RE: Wilson Warehouse
6119 Hanover Rd. NW
Grading and Drainage Plan
Engineer's Stamp Date: 02/25/19
Hydrology File: J10D045

Based upon the information provided in your submittal received 03/01/2019, the Grading & Drainage Plan is **not** approved for Building Permit and SO-19 Permit. The following comments need to be addressed for approval of the above referenced project:

Grading Plan

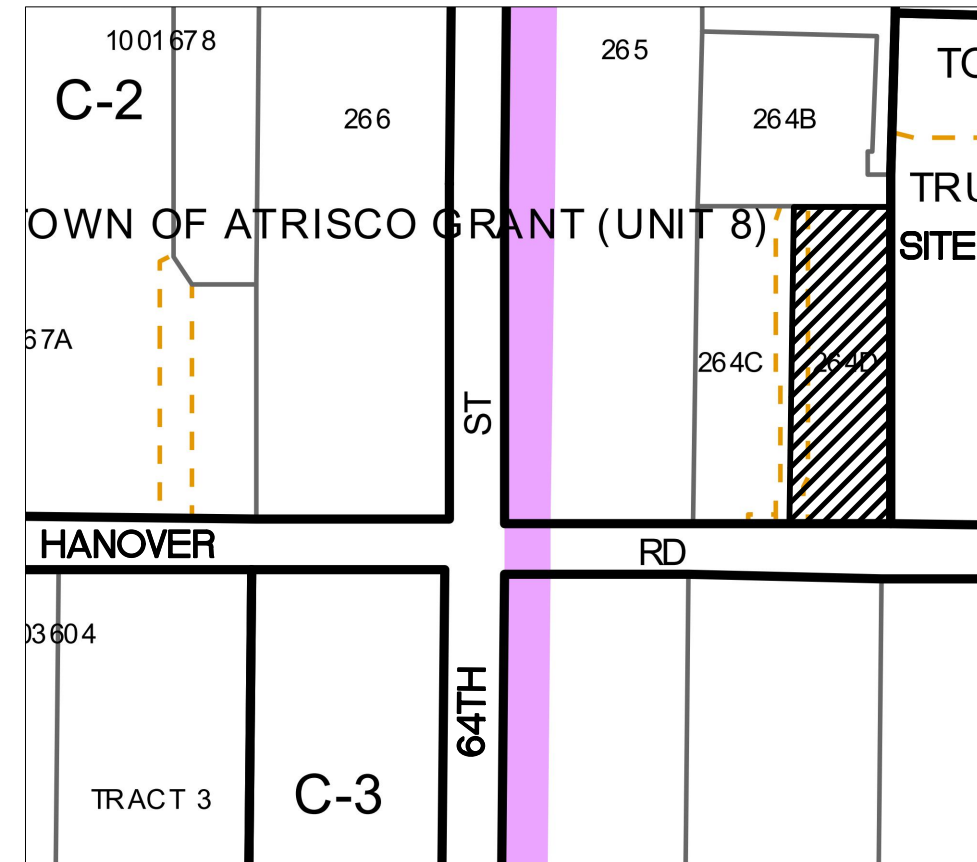
2. Please add a leader and note stating, "Replace/fix section of pond's PVC pipe and place through curb per City of Albuquerque drawing # 2235."
3. Since work within the R.O.W. for the pipe through the curb is needed, please add the SO-19 Permit Notes on the G&D.

4. Please add some kind of note stating, if the existing pond's PVC pipe is damaged during construction, the damaged pipe needs to be replaced.
5. As per the approved permanent Certificate of Occupancy for Tract 264-C dated 6/17/09, the existing pond volume was revised from the required 17,420 cf to 13,074 cf with Tract 264-D conditions as a gravel parking lot. This development is responsible for enlarging the detention pond for the proposed developed conditions. Please provide calculations showing the required volume. If the existing pond volume is sufficient, then routing calculation will need to be provided to back this claim.

6. If the detention pond has to be enlarged, an emergency spillway will have to be installed. The current pond did not have one designed. Also there will need a swale along the east side of the property to Hanover Rd. If this needs to be done, then a sidewalk culvert will need to be installed per City of Albuquerque drawing # 2236. Then the discharge PVC pipe from the pond can also discharge into the sidewalk culvert instead of through the curb.
